Models Affected: 17AA5A4G710 & 17AA5A4G712 (RZT 17), 17AA5A7P710 & 17AA5A7P712 (RZT 22)

Date: **June 3, 2004**

Subject: **Kit 759-04058, key switch and adapter harness**

FIGURE 1

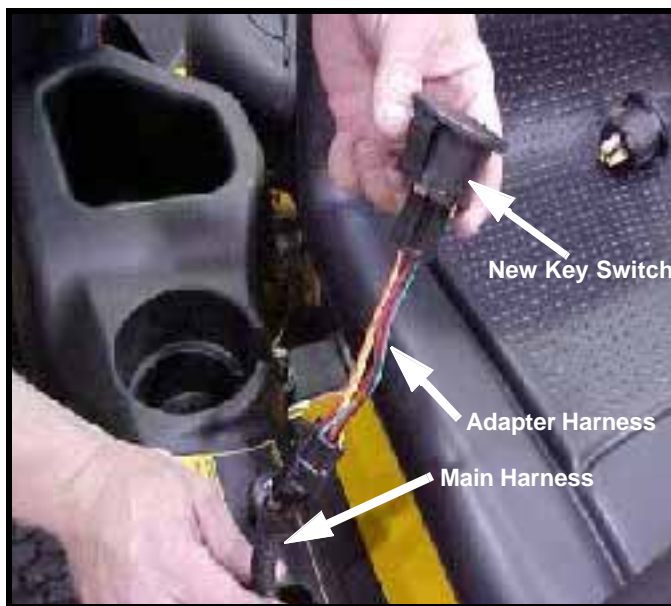
PURPOSE: With the current key switch there is no power to the fuel shut off solenoid when the key is in the start position. This can cause difficult starting after the unit has not been operated for extended periods of time. Order and install kit **759-04058**, this kit consists of key switch 725-04228 and harness 725-04229. Future production will include a change to the harness to eliminate the adapter harness.

From under the right side control panel depress the two retainers on the side of the key switch, push the key switch up and out of the control panel.

Assemble the adapter harness to the new key switch then assemble the other end of the adapter harness to the main harness of the unit.

Route the wire harness back through the hole in the control panel and snap the key switch into place.

From the under side of the control panel make sure that the harness will not come into contact with any moving parts.

Functionally test unit to verify proper operation.
